UNITED STATES PATENT AND TRADEMARK OFFICE

| APPLICATION NO. | FILING DATE | FIRST NAMED INVENTOR | ATTORNEY DOCKET NO. | CONFIRMATION NO. |
|---|-------------|----------------------|---------------------|------------------|
| 10/628,500 | 07/28/2003 | Makoto Miyazawa | NEKU 20.544 | 5066 |

Office Action Summary

DETAILED ACTION

Fig. 3 PRIOR ART

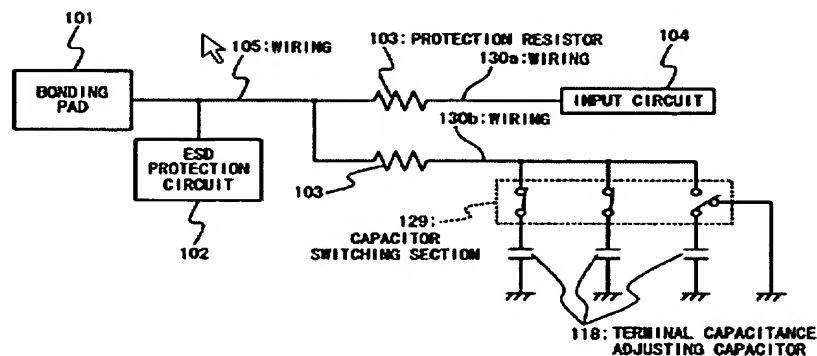
3. Claim 1 is rejected under 35 U.S.C. 102(b) as being anticipated by the Applicants' Admitted Prior Art (AAPA) in this application.

In re claim 1, AAPA discloses a semiconductor integrated circuit device comprising: a terminal 101; and a first capacitance adjusting section 129 which is connected to a wiring 105 between the terminal 101 and a protection resistor 103 in a front stage of an internal circuit 104; and a protection circuit 102 which is connected to the wiring 105 between the terminal 101 and the first capacitance adjusting section 129, the protection circuit 102 inherently protecting the internal circuit 104, wherein the first capacitance adjusting section 129 adjusts terminal capacitance of the terminal 101, based

on capacitance of the first capacitance adjusting section (AAPA, Background of the invention, Description of the Related Art in Pages 3-4 and FIG. 3).

FIG.2

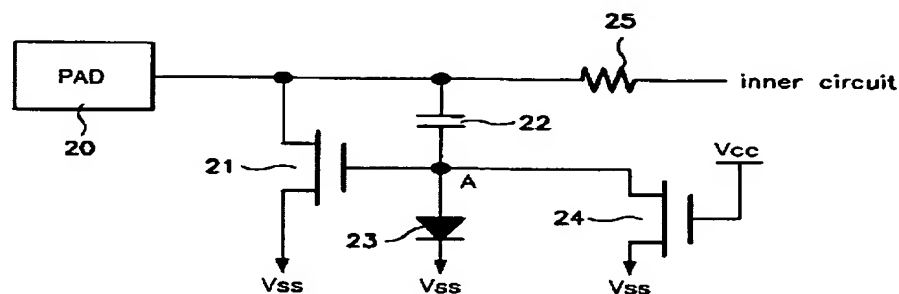
5. Claims 1, 3 and 7 are rejected under 35 U.S.C. 102(e) as being anticipated by Chang (U.S. Patent 6,611,407).

In re claim 1, **Chang** discloses a semiconductor integrated circuit device comprising: a terminal 20; and a first capacitance adjusting section 22 which is connected to a wiring (unlabeled) between the terminal 20 and a protection resistor 25 in a front stage of an internal circuit (inner circuit); and a protection circuit 21 which is connected to the wiring between the terminal 20 and the first capacitance adjusting section 22, the

protection circuit 21 inherently protecting the internal circuit, wherein the first capacitance adjusting section 22 adjusts terminal capacitance of the terminal 20, based on capacitance of the first capacitance adjusting section (col. 3, lines 28-56 and FIG. 2).

FIG.2

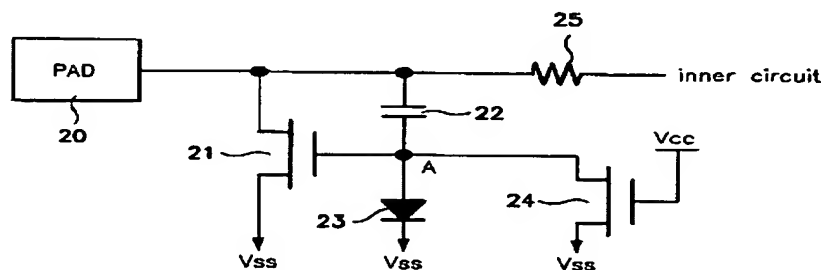
In re claim 3, Chang discloses a semiconductor integrated circuit device comprising: a terminal 20; and a first capacitance adjusting section 22 which is connected to a wiring (unlabeled) between the terminal 20 and a protection resistor 25 in a front stage of an internal circuit (inner circuit), wherein the first capacitance adjusting section 22 adjusts terminal capacitance of the terminal 20, based on capacitance of the first capacitance adjusting section, wherein the first capacitance adjusting section 22 comprises a first adjusting capacitor which adjusts the terminal capacitance (col. 3, lines 28-56 and FIG. 2), and
